CITY OF WINTER PARK PLANNING AND ZONING BOARD

Staff Report May 7, 2019

SPR 19-05 REQUEST OF Z PROPERTIES FOR APPROVAL TO CONSTRUCT A NEW 4,528-SQUARE FOOT SINGLE-FAMILY HOME LOCATED AT 1204 N PARK AVENUE ON LAKE MAITLAND, ZONED R-1AAA.

SPR 19-04 REQUEST OF Z PROPERTIES FOR APPROVAL TO CONSTRUCT A NEW 5,314-SQUARE FOOT SINGLE-FAMILY HOME LOCATED AT 394 HENKEL CIRCLE ON LAKE VIRGINIA, ZONED R-1AAA.

SITE PLAN

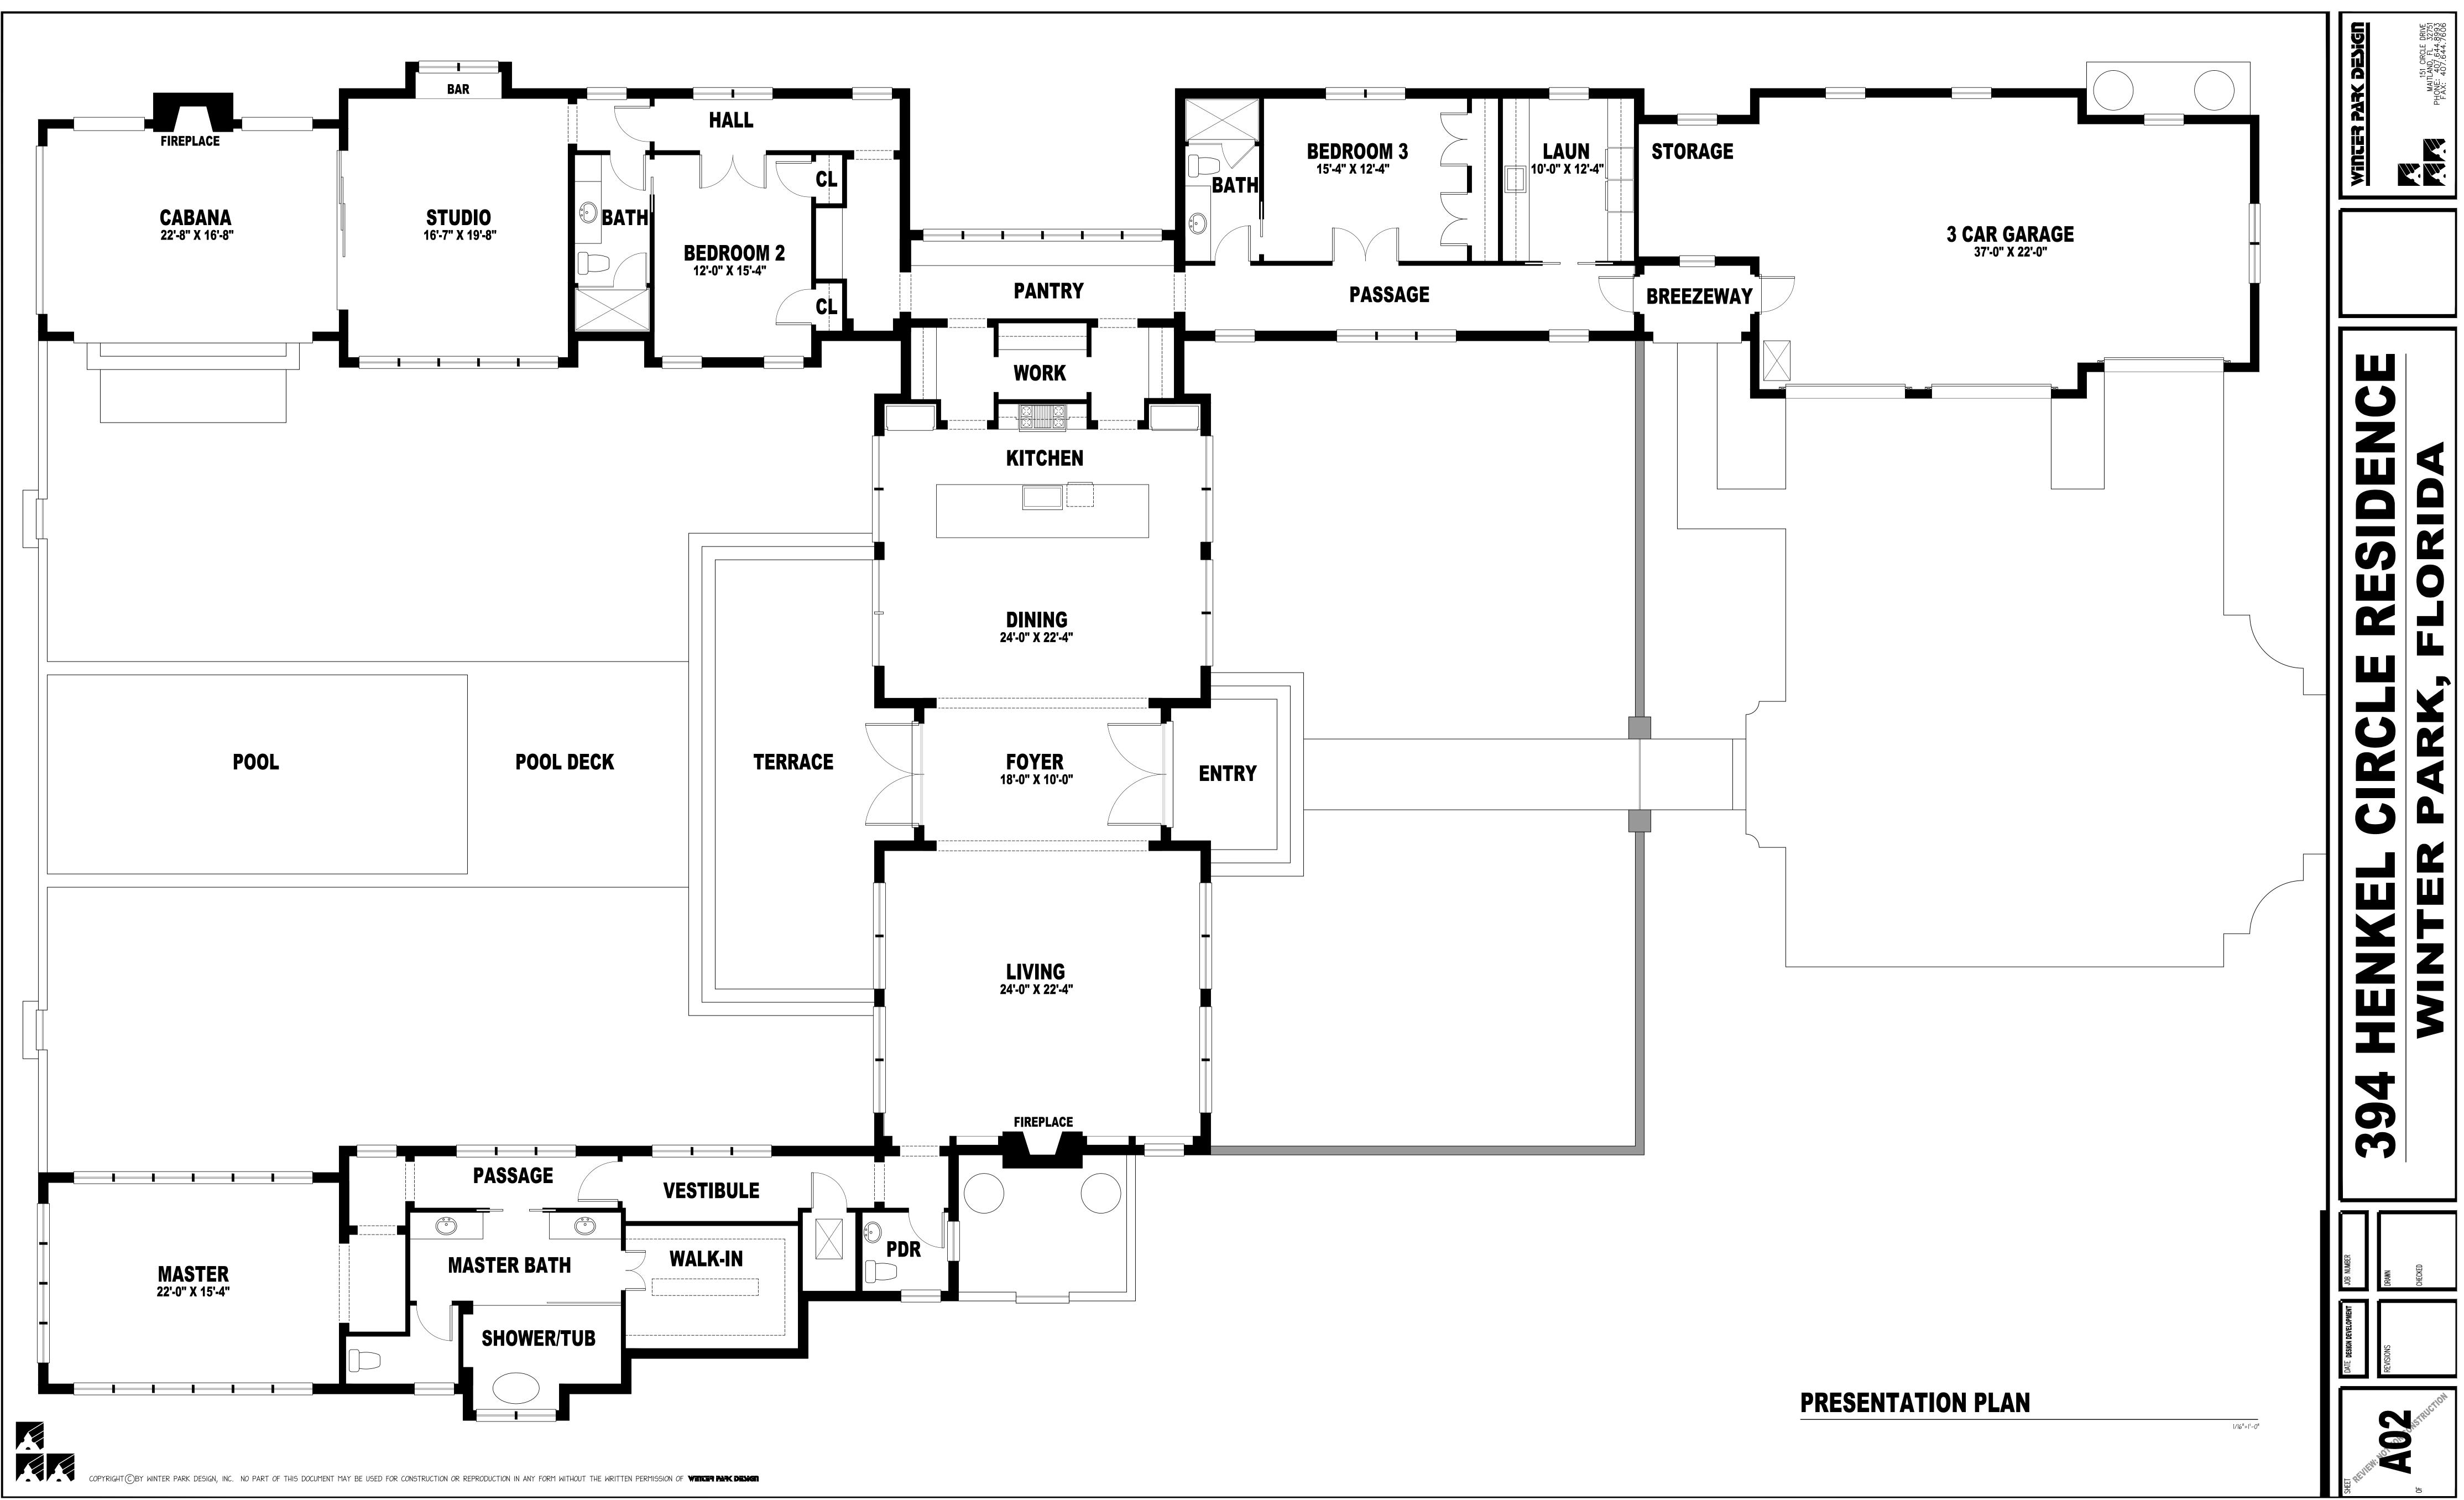
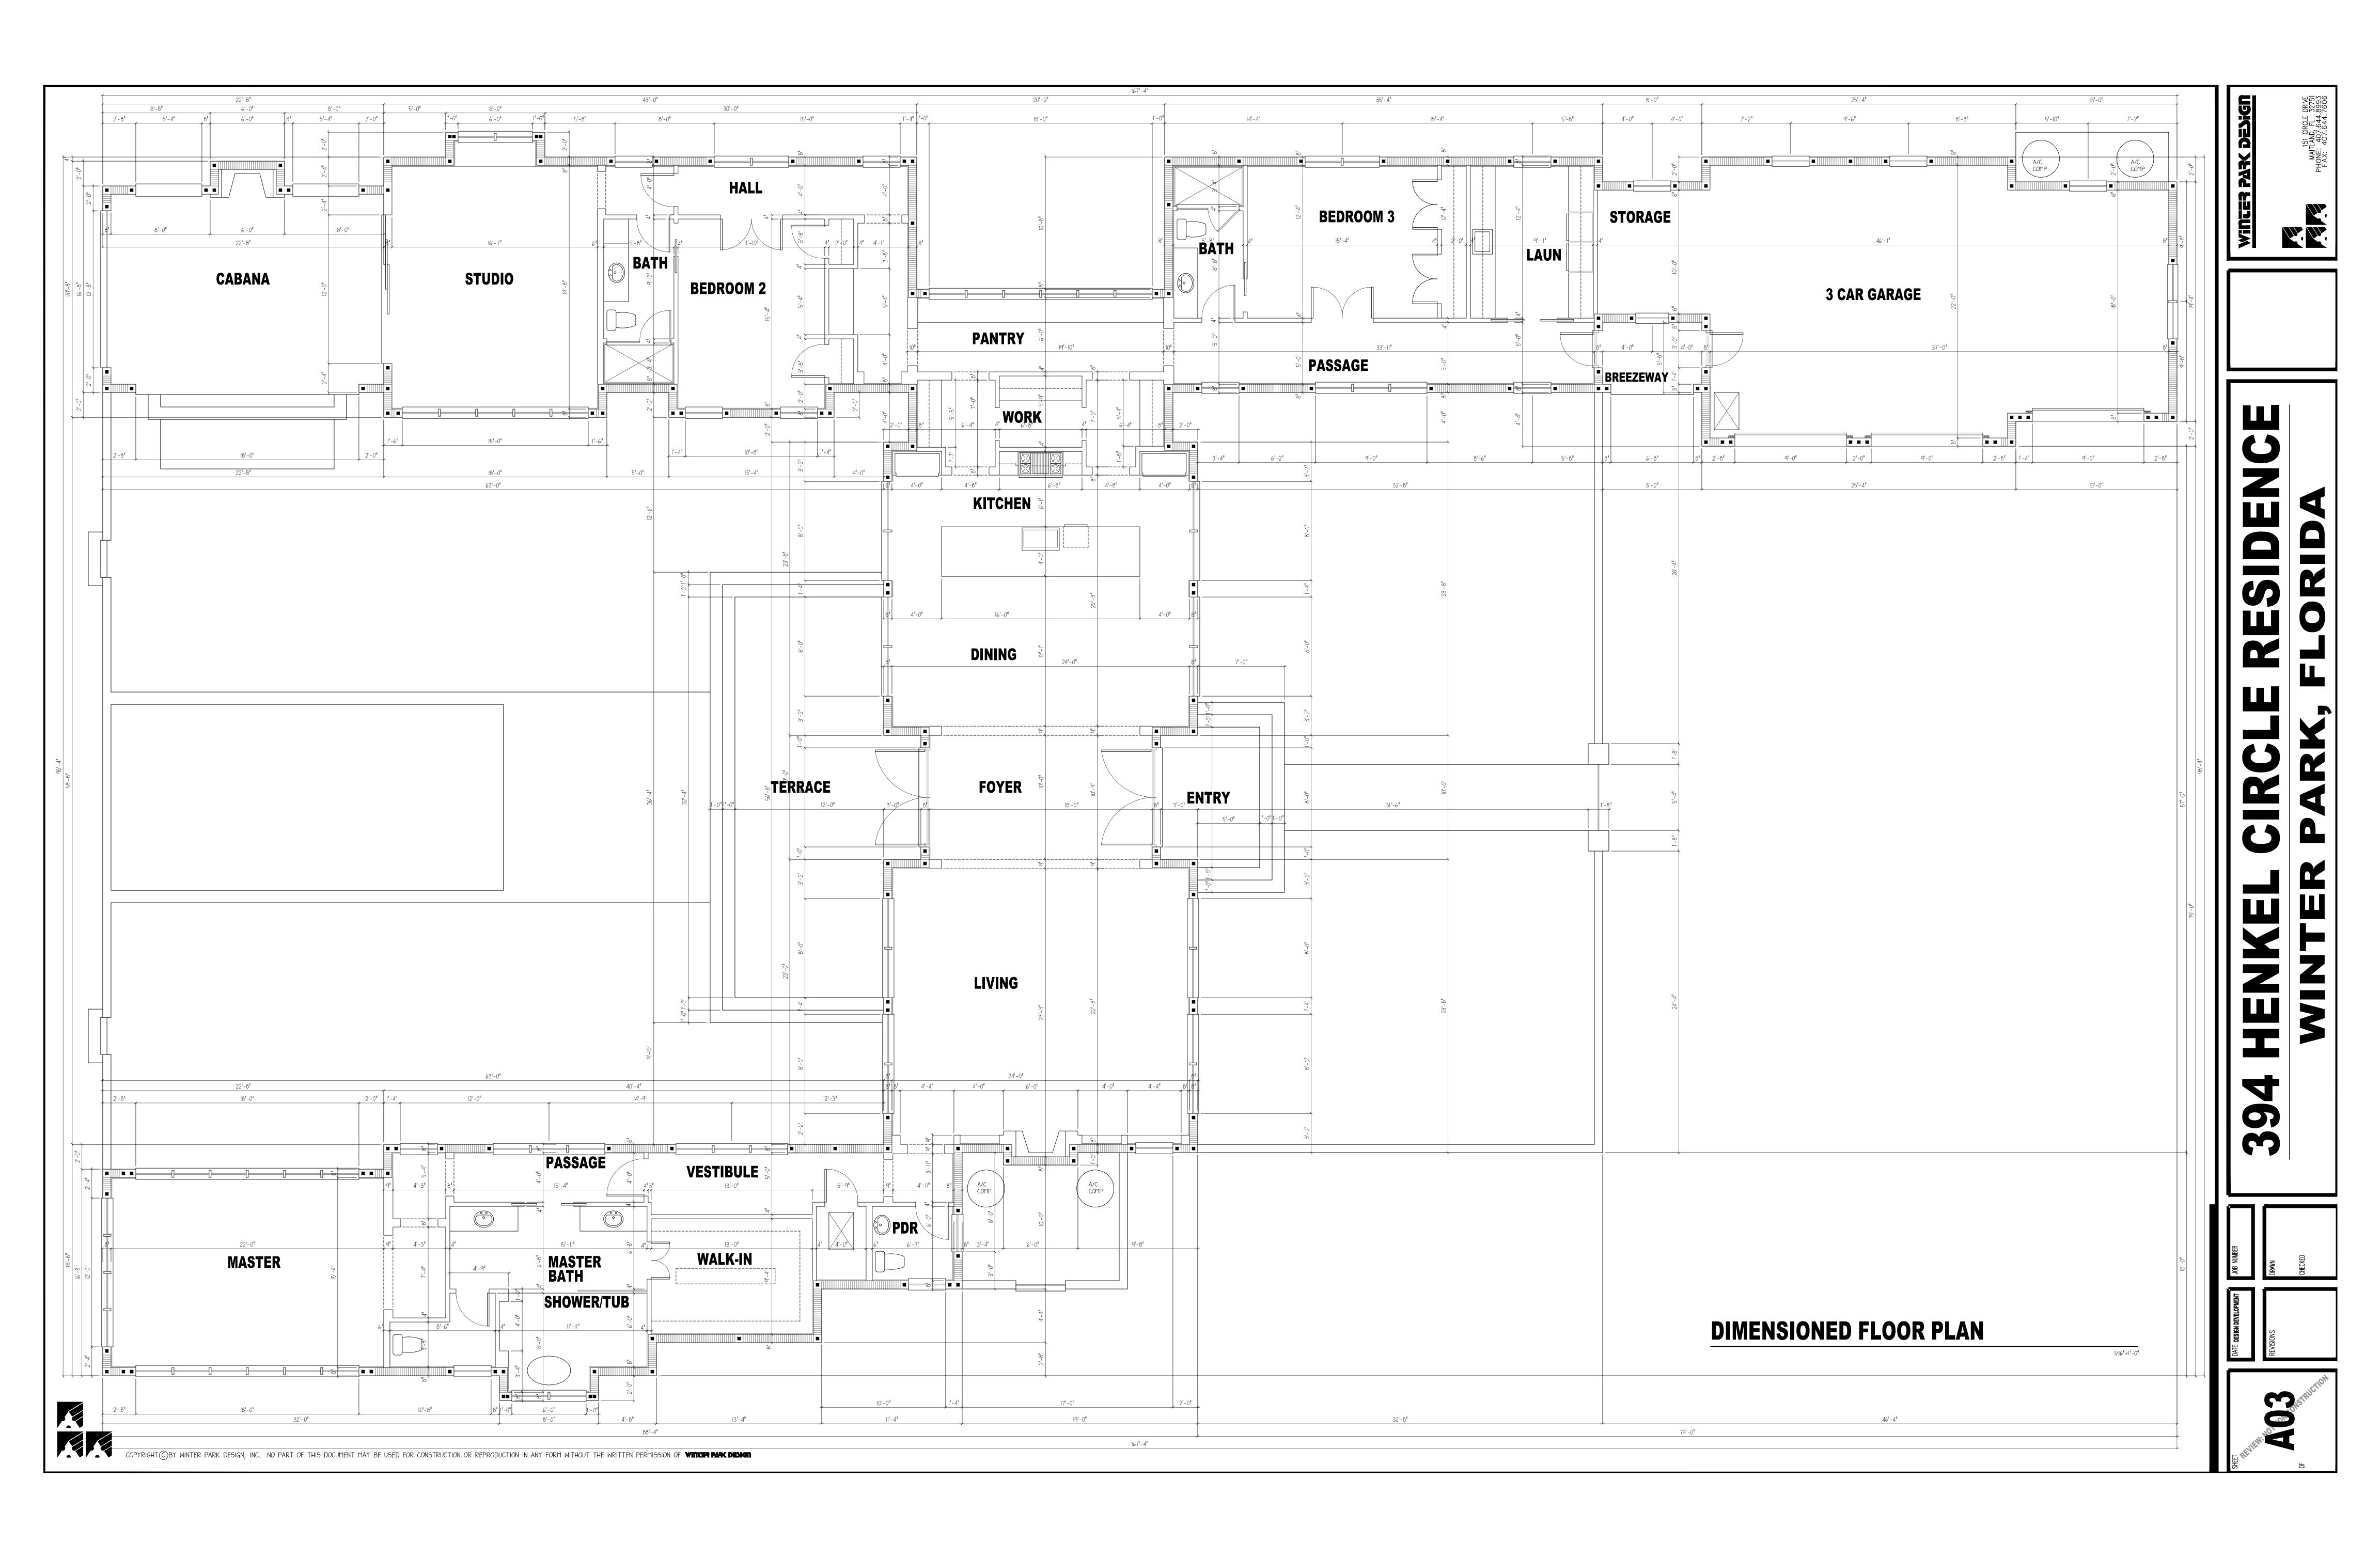
VIEW OF NEIGHBORS: The Code states that the lakefront setback shall be the average established by the adjacent lakefront properties within 200 feet of the subject property, or 50 feet, whichever is greater. This home will be significantly setback from the lakefront, at approximately 118-158 feet from the normal high water line. However, due to the substantial difference between the lakefront setback of the adjacent homes, the average setback is approximately 150 feet. The Code direction is to minimize the degradation of traditional views across properties by new houses, additions, second story additions, etc. alongside property lines toward the lake that may block traditional views. The P&Z Board does have the authority to approve setbacks less than the average determined. Staff does not see a concern with the lakefront setback proposed by the applicant, as it will not impede the existing views of the lake of the neighboring properties due to the extensive vegetation between each property line and the angle of the lakefront.

STORM WATER RETENTION: The zoning code requires retention of storm water so that storm water flowing over a waterfront lawn area does not carry with it into the lake any fertilizers, herbicides, etc. Typically, this retention requirement is accomplished by the creation of a depressed swale area across the waterfront of about one foot in depth. The amount of impervious surface determines the need for the depth of the swale. The applicant is proposing a stormwater swale near the lakefront that is sized to meet the City's code requirements.

STAFF RECOMMENDATION IS FOR APPROVAL
